March 5, 2009

Subject: UniStar Nuclear Energy, NRC Docket No. 52-016  
Calvert Cliffs Nuclear Power Plant, Unit 3  
Environmental RAIs No. 1001 through 1011

The purpose of this letter is to respond to the requests for additional information (RAIs) identified in the NRC letter to UniStar dated February 3, 2009 (Reference 1). The RAIs address figures needed to publish the environmental impact statement (EIS) and information necessary for completion of regulatory reviews.

**FIGURE 2.5-3** Rev. 0  
 (CCNPP UNITS 1, 2, AND 3)  
 LOW POPULATION ZONE  
 CCNPP UNIT 3 ER

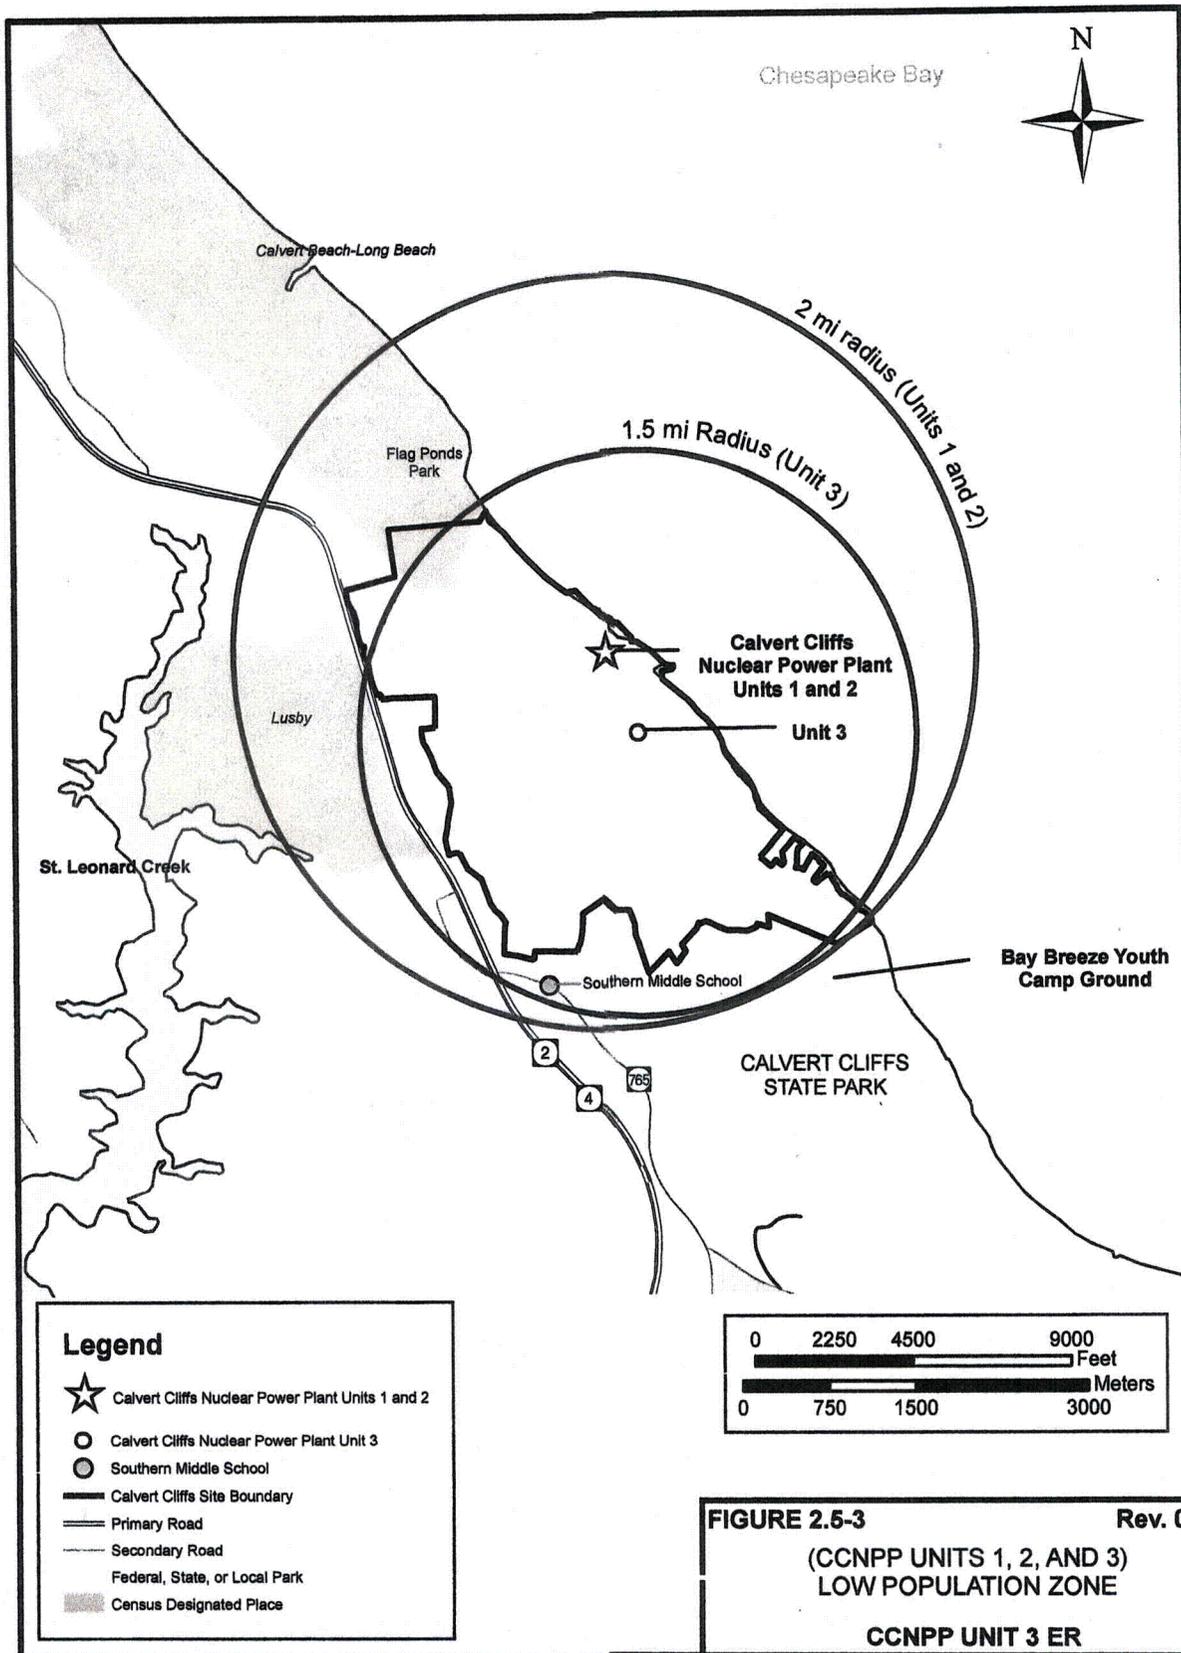
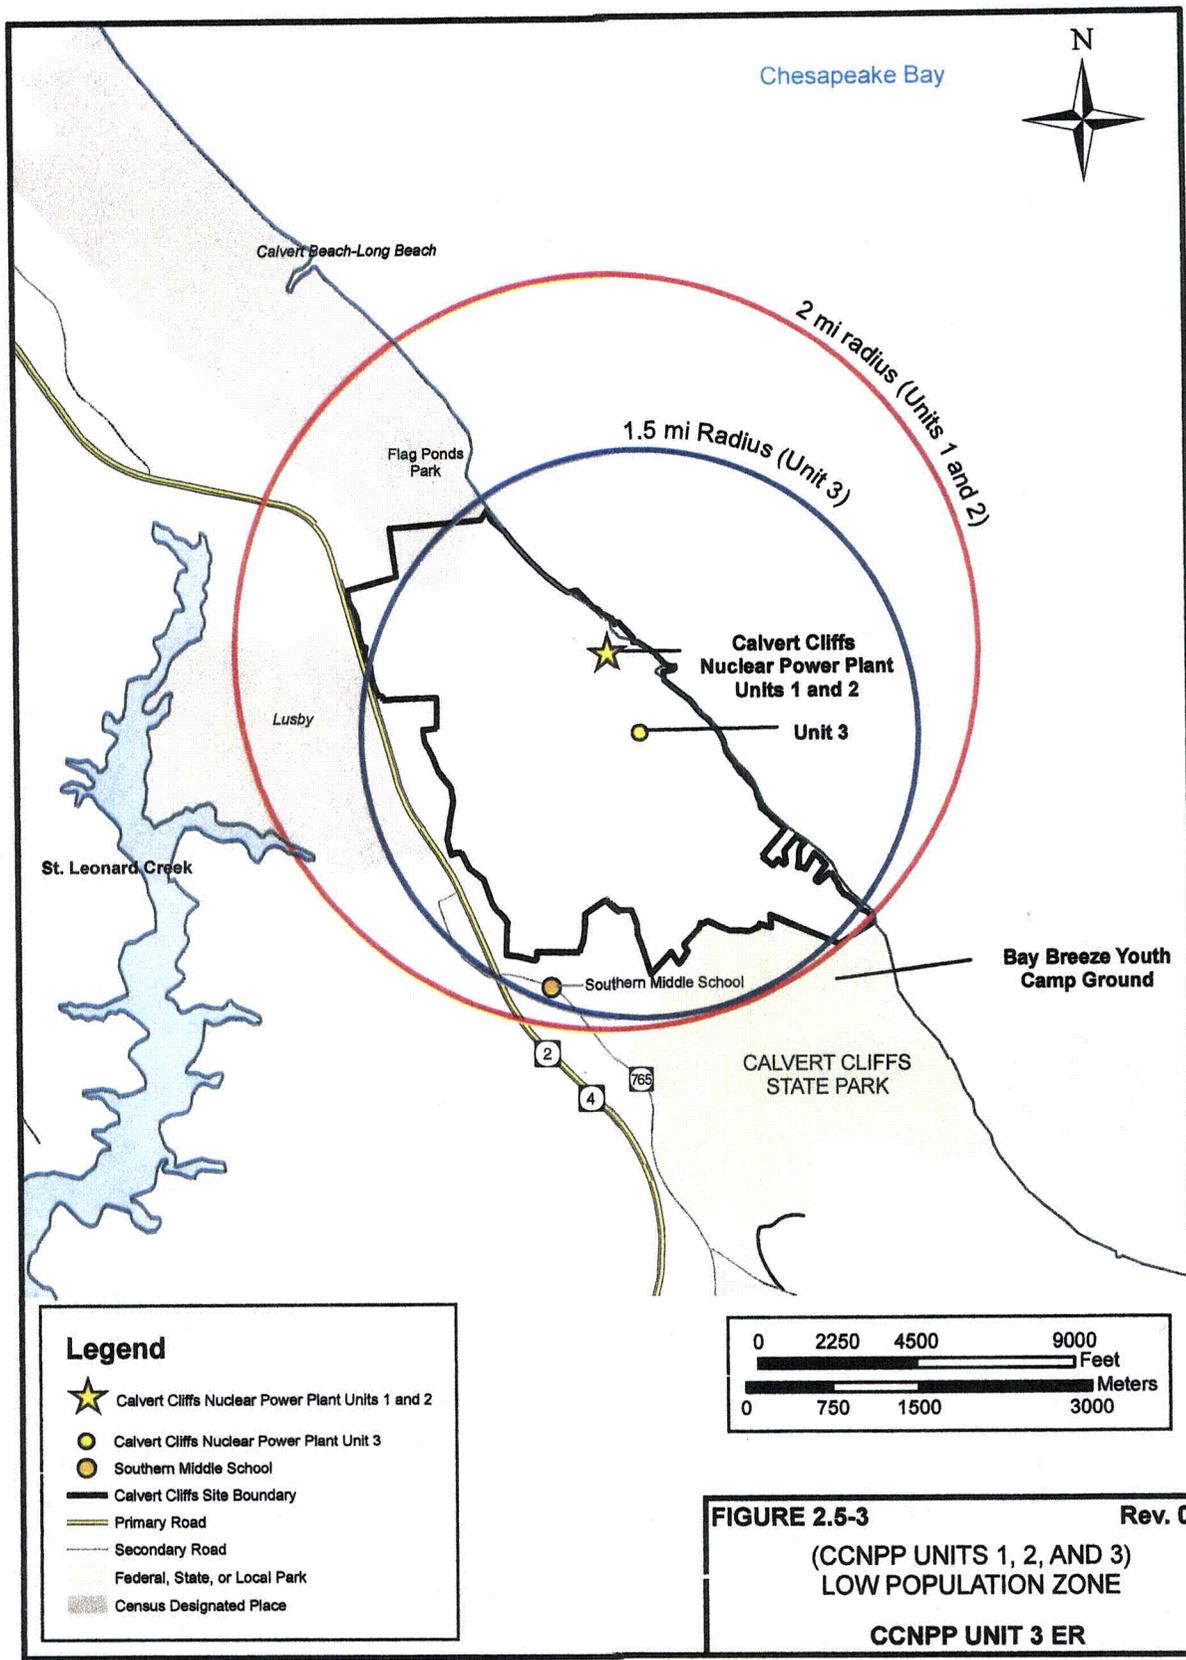
Provide a legible graphic of ER Fig 2.5-3 so that it has sharper (not fuzzy) titles and no distracting background "textures."

UniStar has prepared a figure for use in the printed version of the EIS. See attached black and white figure.

The CCNPP Unit 3 Environmental Report will be updated to incorporate the response to this RAI question in a future COLA revision, as shown in the attached color figure.

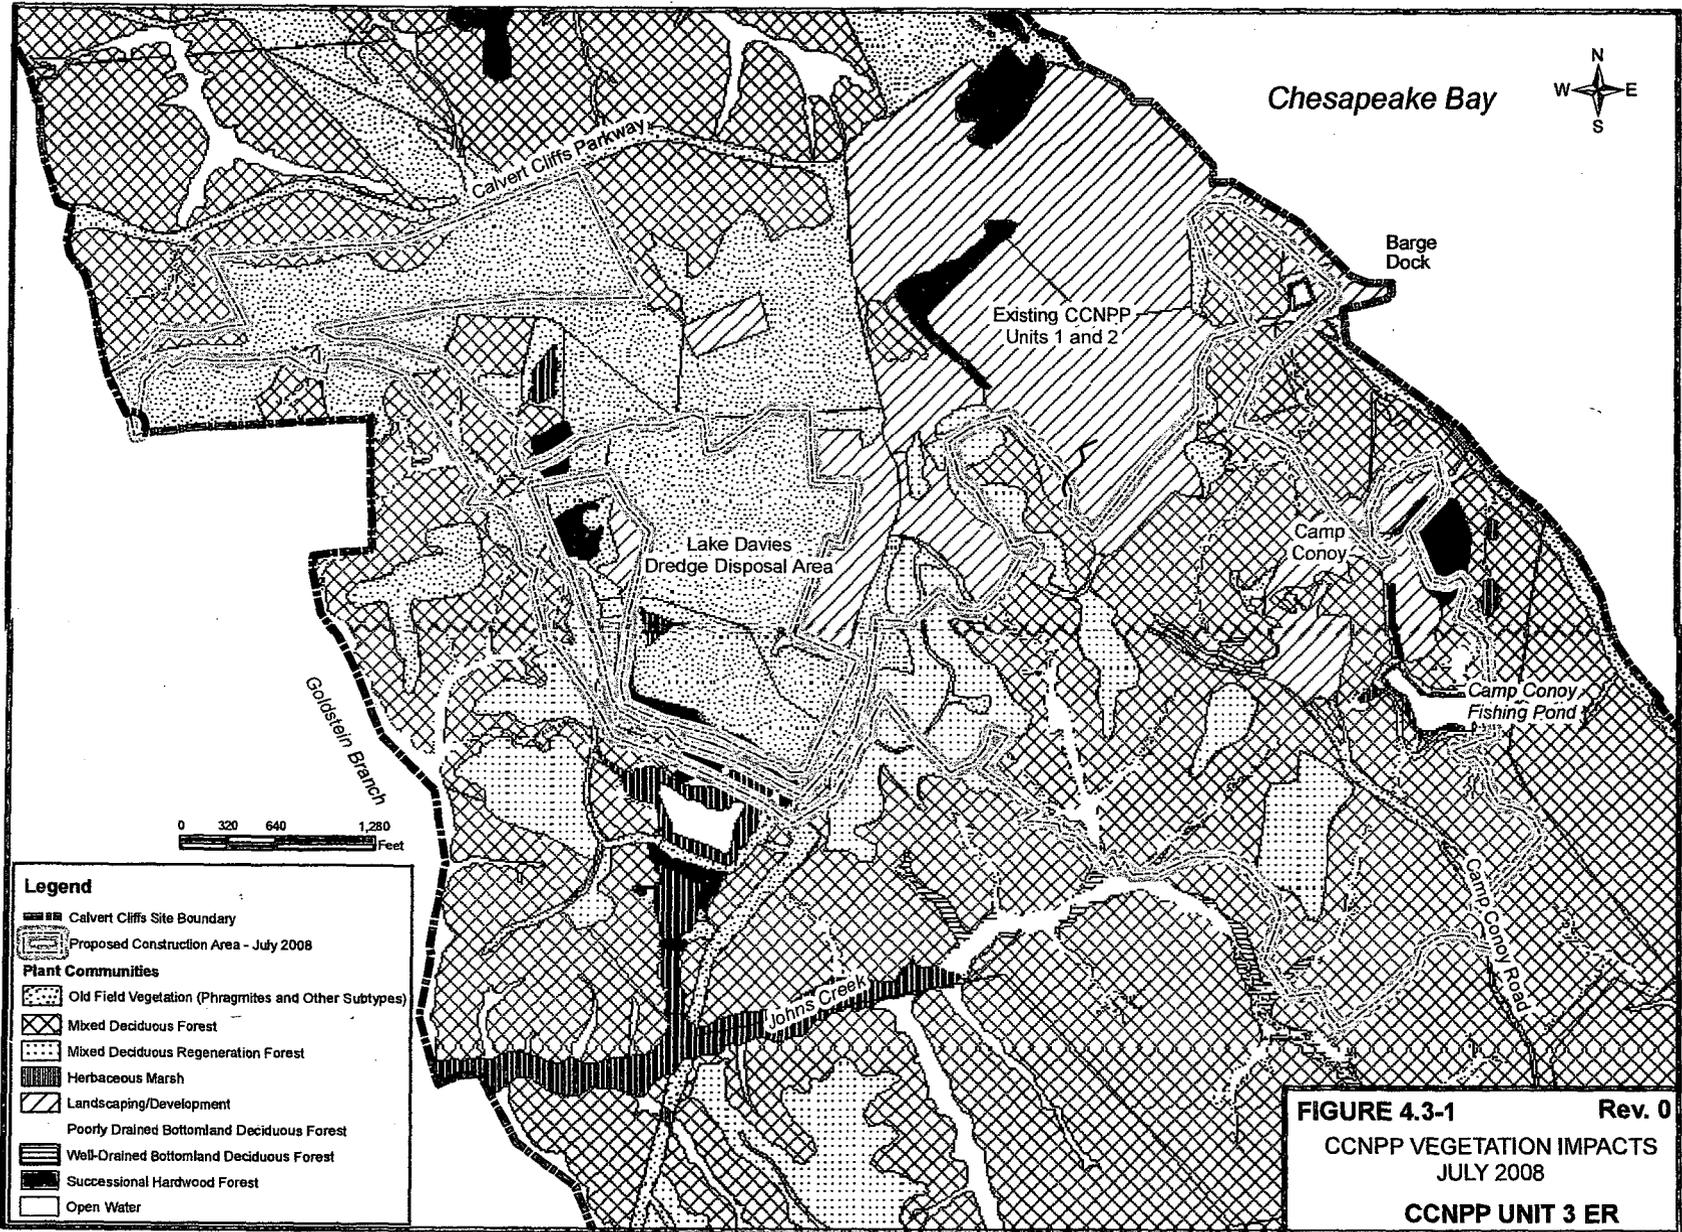
Provide a legible graphic of ER Fig 4.3-1 with a legible legend depicting only the following attributes: Calvert Cliffs site boundary, Chesapeake Bay label, Proposed construction areas and labels superimposed over the following plant communities: Mixed Deciduous Forest, Old Field (Phragmites and Other subtypes combined), Landscaping/Development, Mixed Deciduous Regeneration Forest, Well-drained Bottomland Deciduous Forest, Poorly Drained Bottomland Deciduous Forest, Herbaceous Marsh, Successional Hardwood Forest.

UniStar has prepared a figure for use in the printed version of the EIS. See attached black and white figure.

The CCNPP Unit 3 Environmental Report will be updated to incorporate the response to this RAI question in a future COLA revision, as shown in the attached black and white mark up.

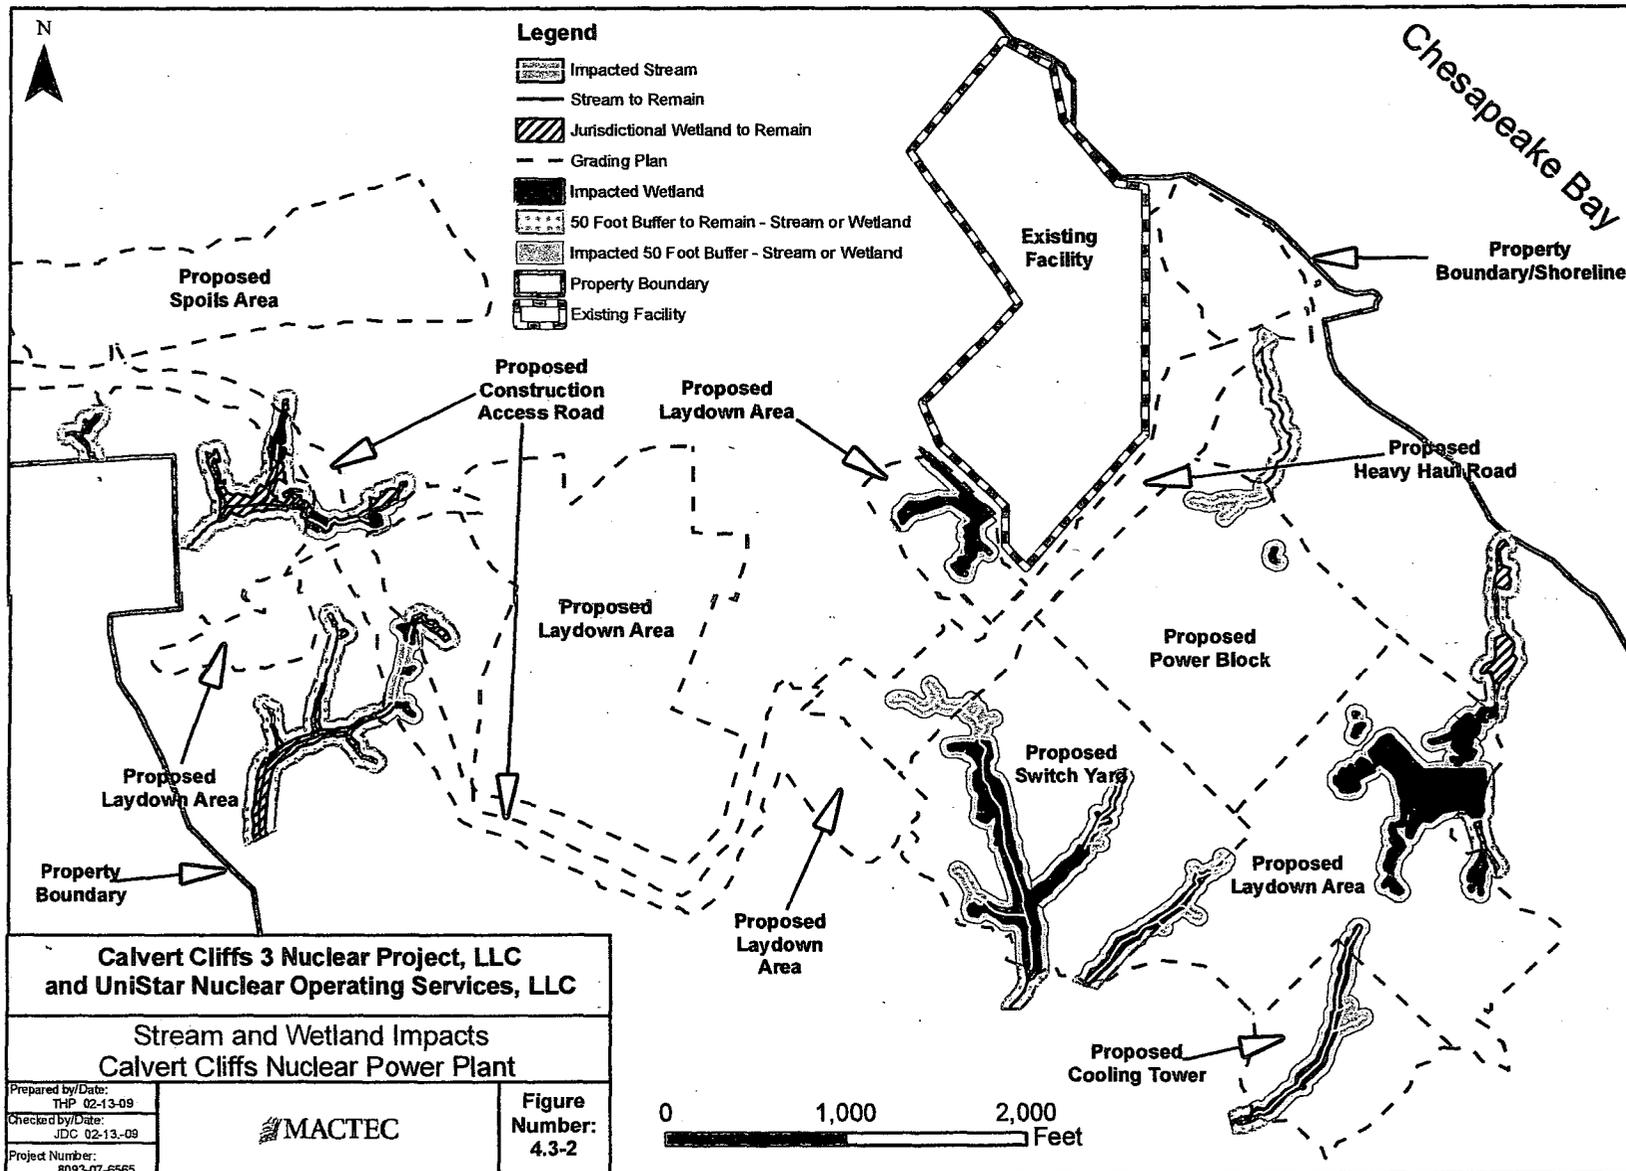
Provide a legible graphic of ER Fig 4.3-2 with a legible legend depicting only the following attributes: Calvert Cliffs site boundary, Chesapeake Bay label, proposed construction areas and labels superimposed over the wetlands and wetland buffers.

UniStar has prepared a figure for use in the printed version of the EIS. See attached black and white figure.

The CCNPP Unit 3 Environmental Report will be updated to incorporate the response to this RAI question in a future COLA revision, as shown in the attached black and white figure.

**ESRP 4.3.1 - 3**

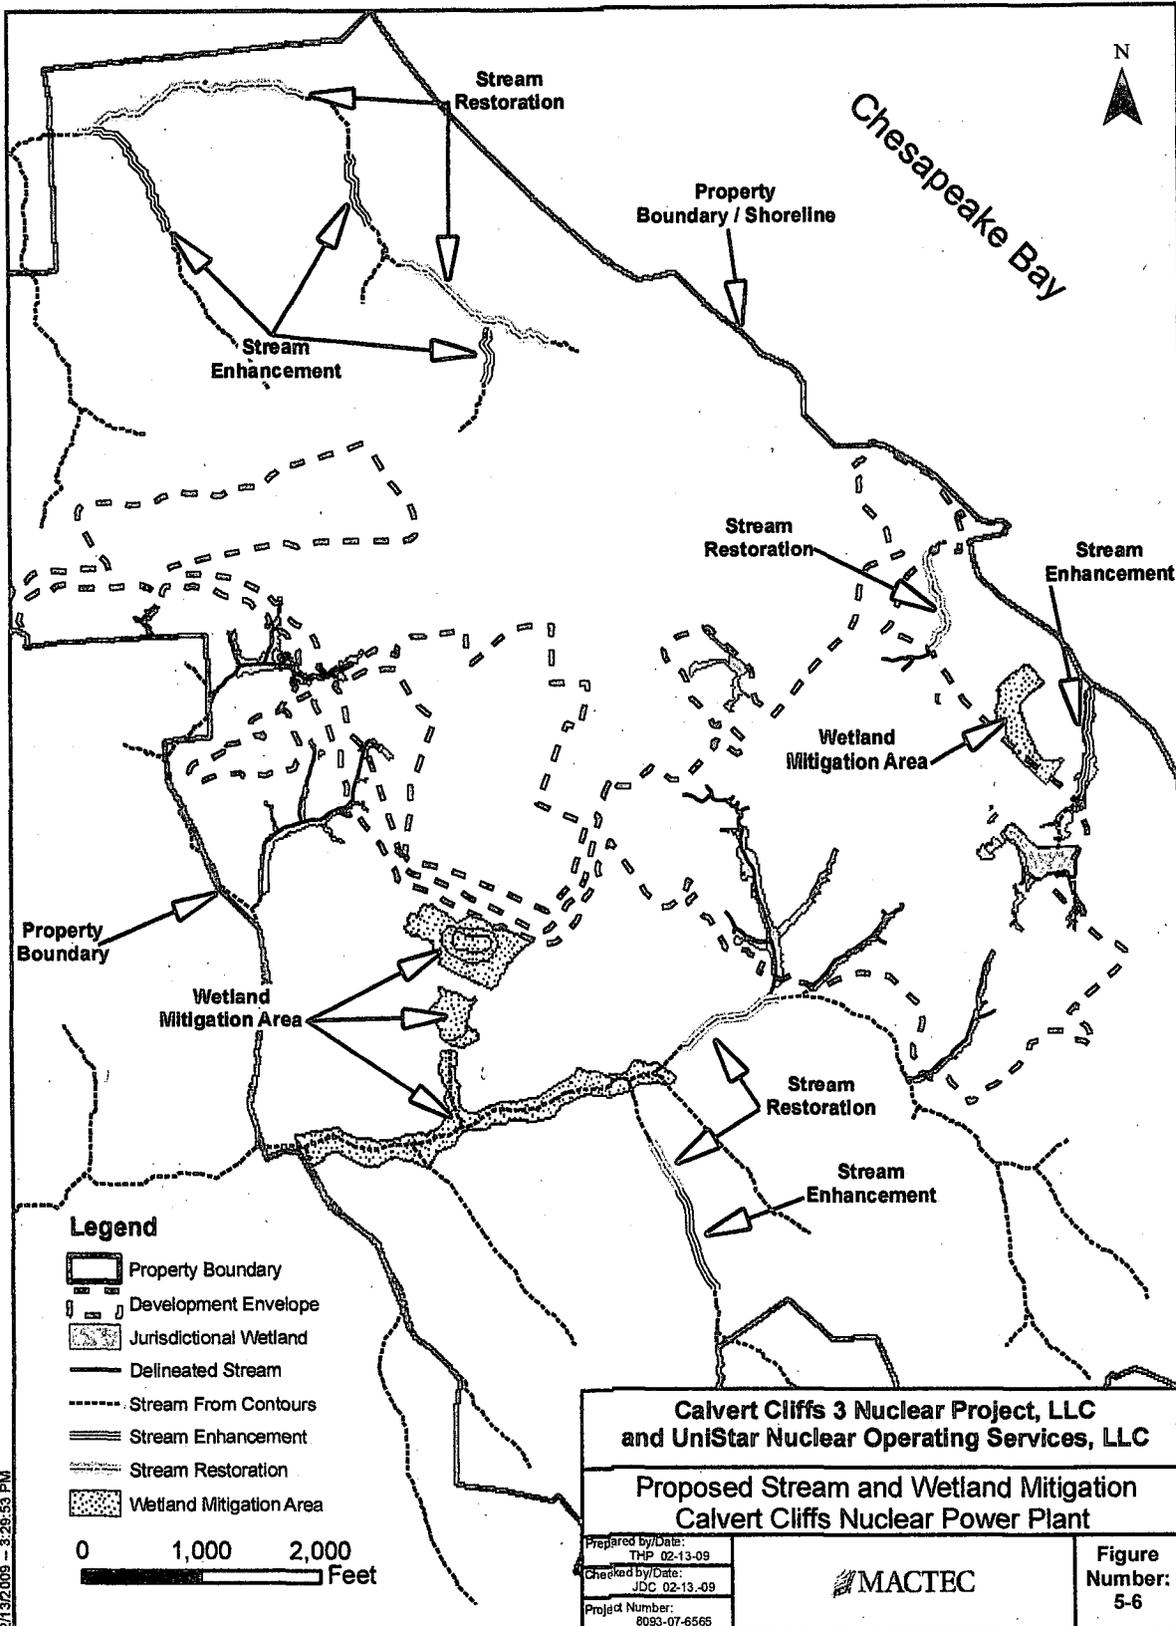
Provide a legible graphic of Fig 5-6 from CPCN Final Report 16 July 2008, with a legible legend depicting only the following attributes: Calvert Cliffs site boundary, Chesapeake Bay label, Wetlands, Development Envelope, and proposed Wetland Mitigation Actions.

UniStar has prepared a figure for use in the printed version of the EIS. See attached figure.
